File Number	PLPR-2408-0001		Contact	Jason Mozol, jmozol@duluthmn.gov	
Type	MU-C Planning Review		Planning Commission Date	October 8, 2024	
Deadline for Action	Application Date	August 28, 2024	60 Days	October 28, 2024	
	Date Extension Letter Mailed	October 2, 2024	120 Days	December 26, 2024	
Location of Subject	West Arrowhead Rd				
Applicant	Force 1 LLC		Contact	Jesse Carlson	
Agent	Titanium Partners		Contact		
Legal Description	010-1773-00020				
Site Visit Date	September 18, 2024		Sign Notice Date	September 24, 2024	
Neighbor Letter Date	September 19, 2024		Number of Letters Sent	7

Proposal

The applicant is proposing a new 4,000 square foot dental clinic on West Arrowhead Rd in a MU-C district. This project is phase 2 of Titanium's development of this site that included Bell Bank's new location completed earlier this year, which is adjacent to the dental clinic lot.

DENTIST OFFICE
DULUTH, MN

EXTERIOR ELEVATIONS

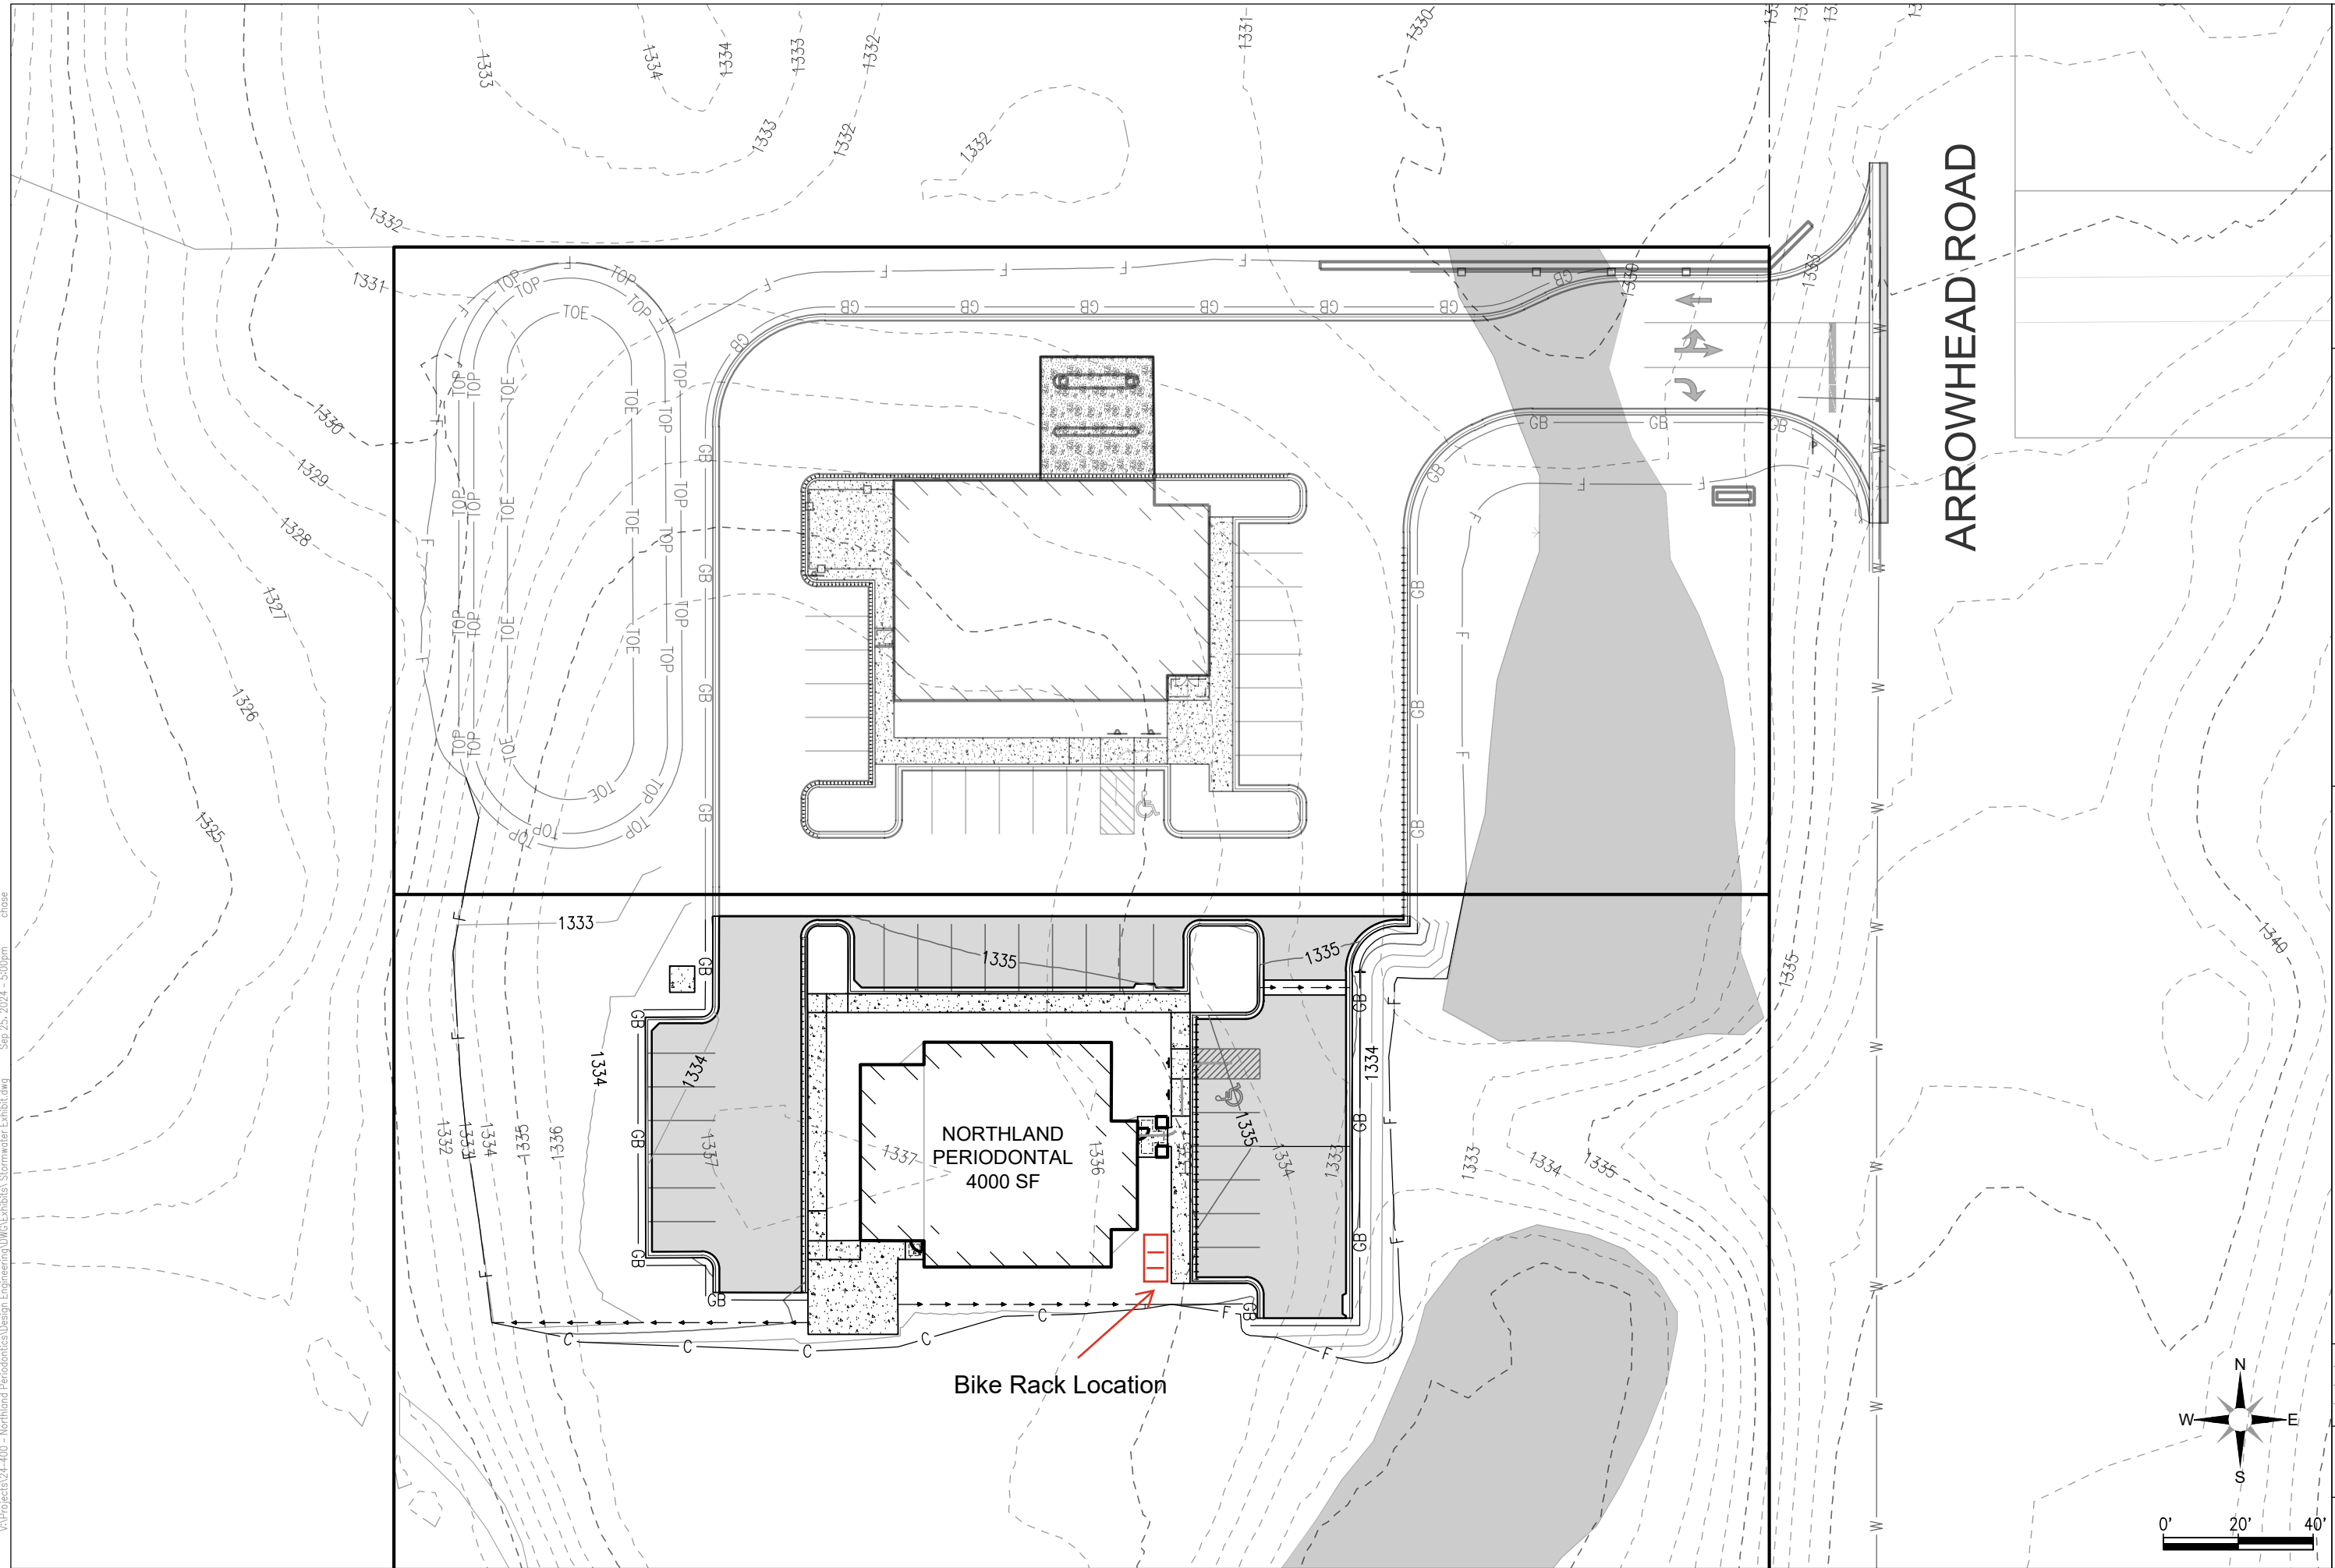
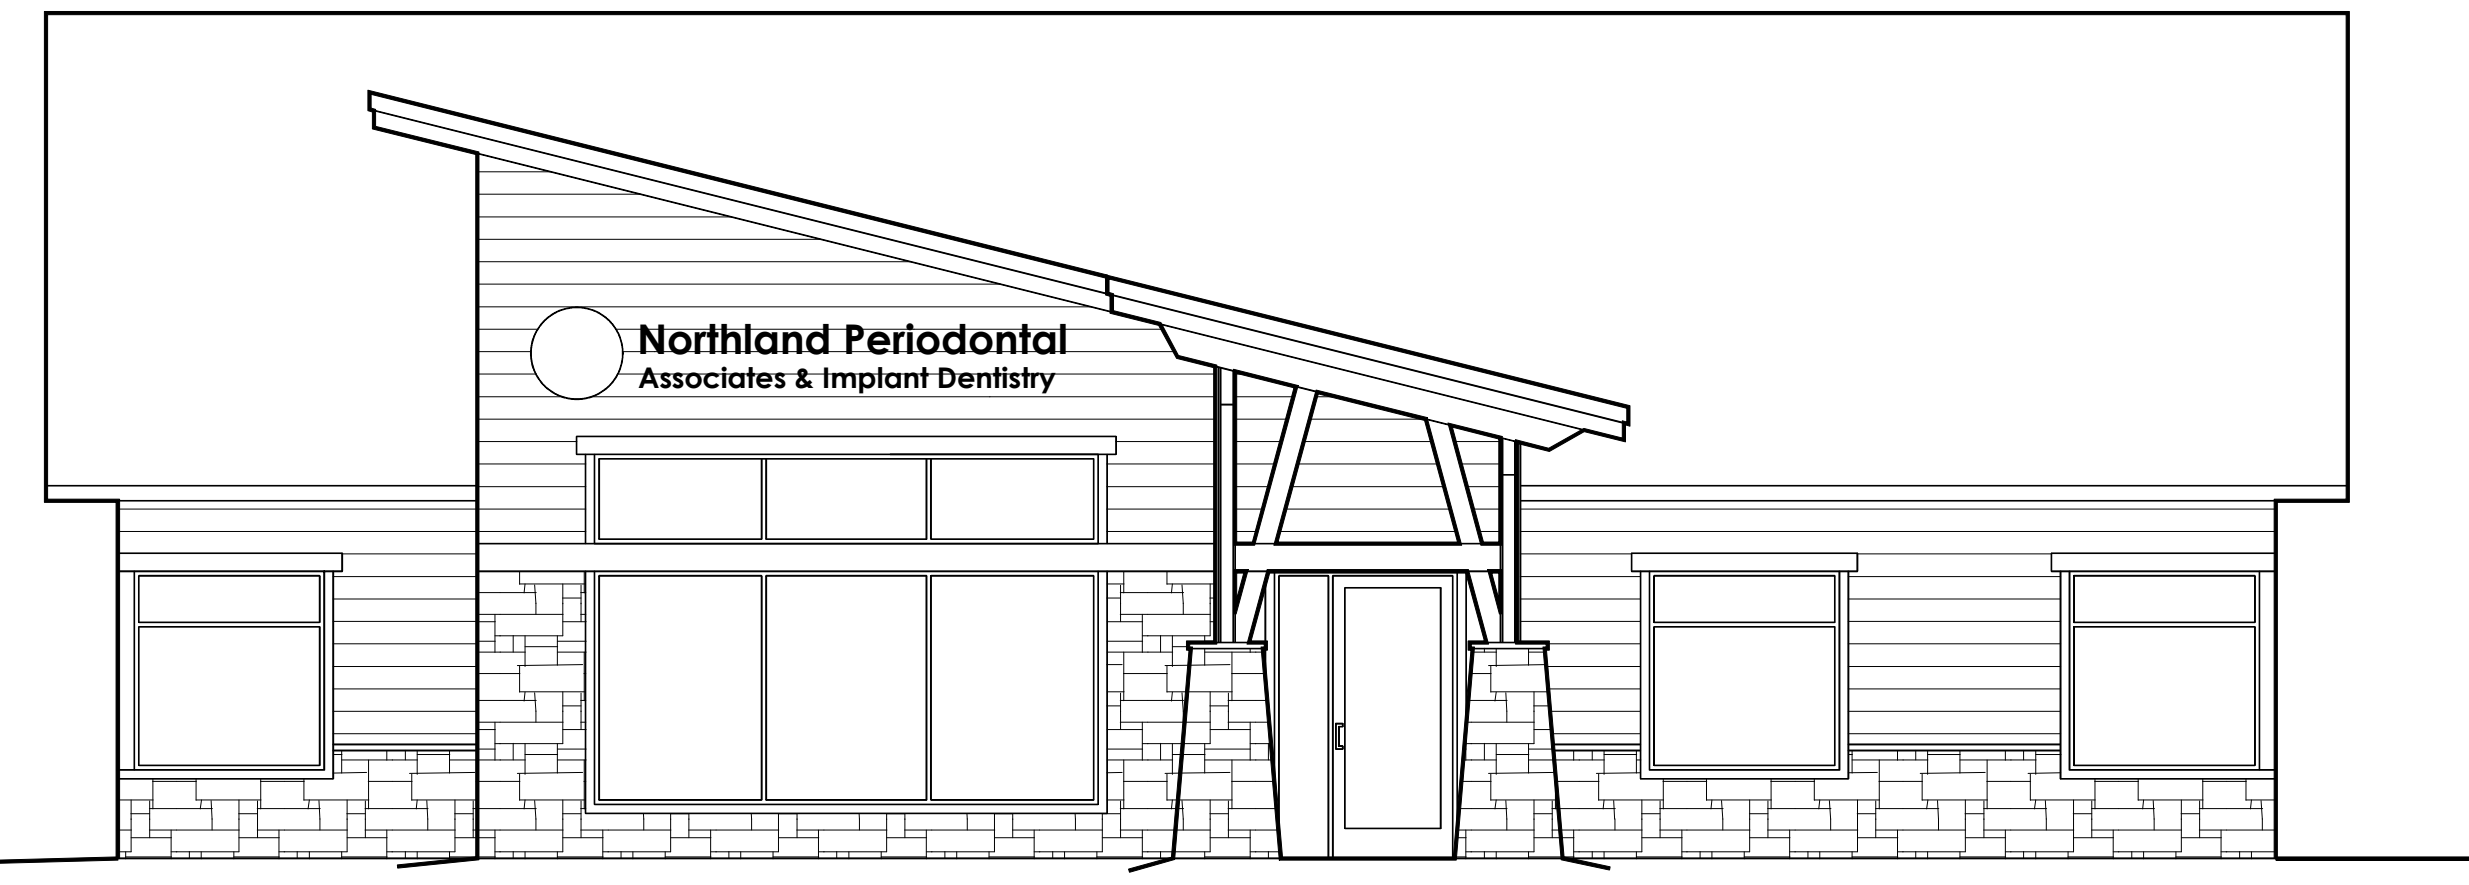
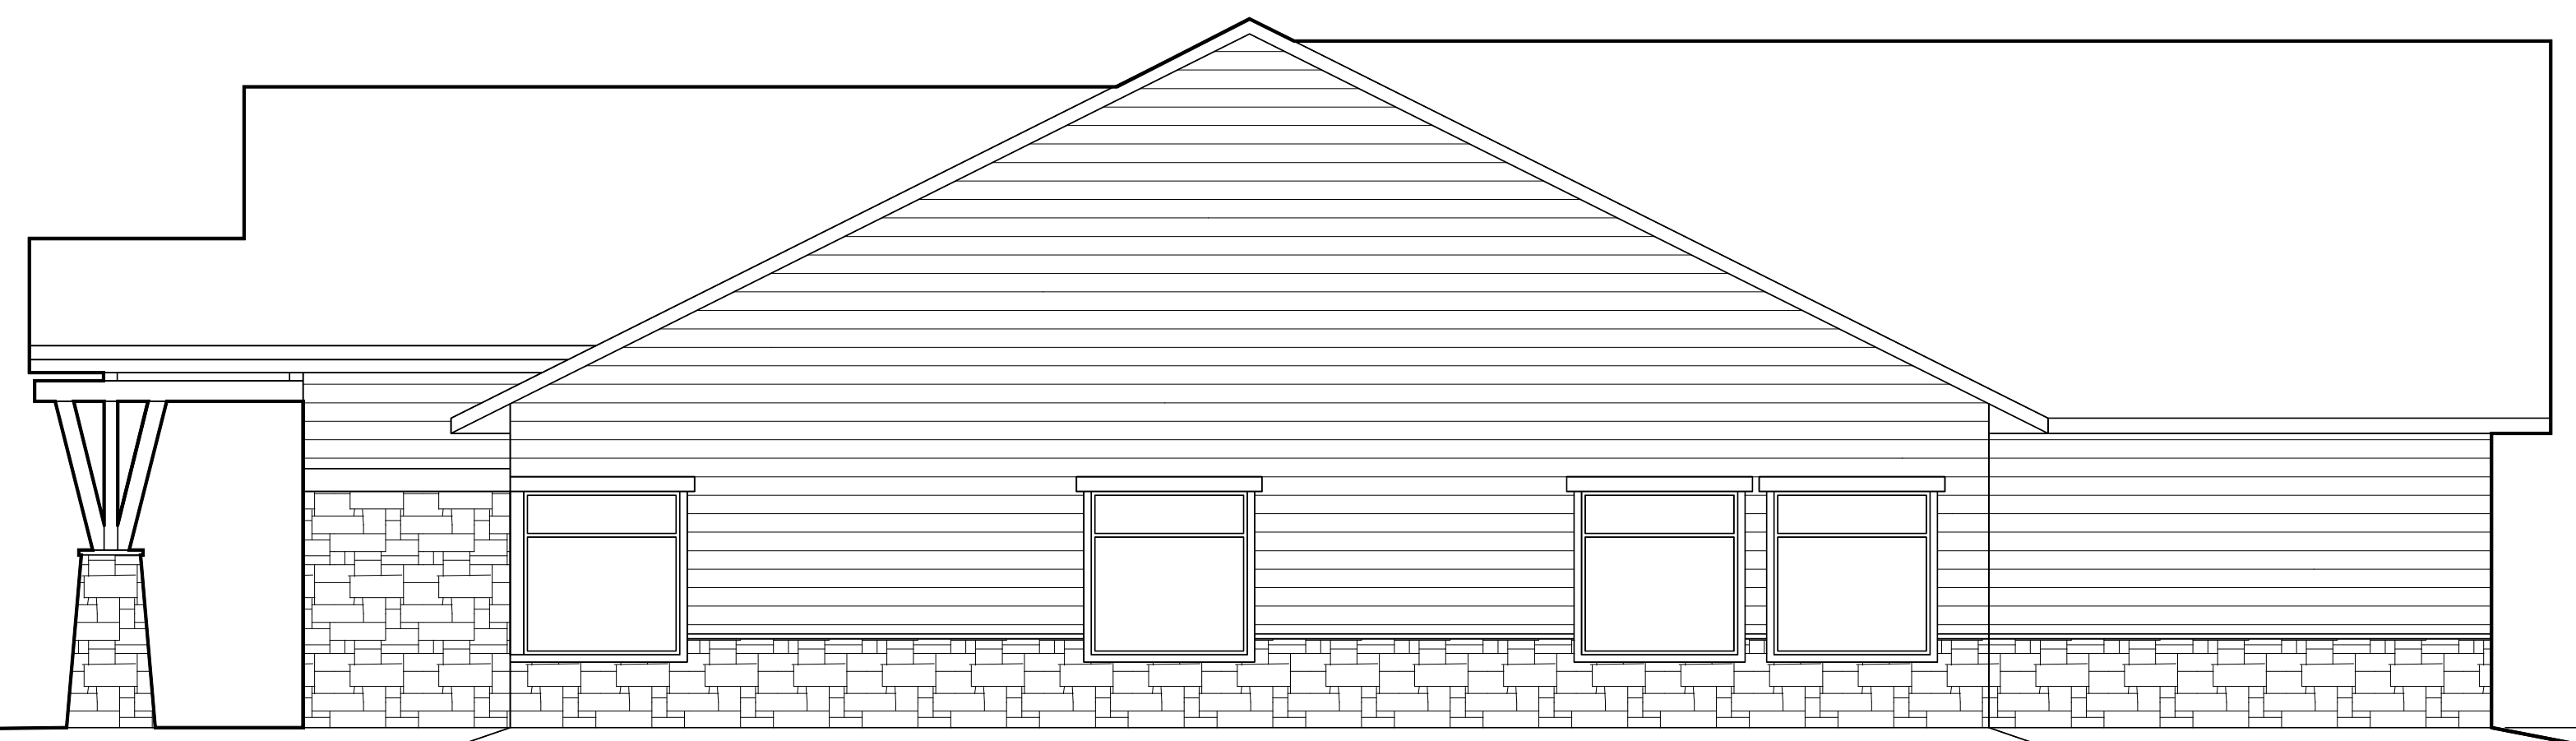
7. Sec. 50-29 (Sustainability Standards). Does not apply because the structure is under 10,000 square feet.
8. Sec. 50-30 (Building Design Standards). The proposed structure meets these requirements for transparency, roof articulation, and entryway design.
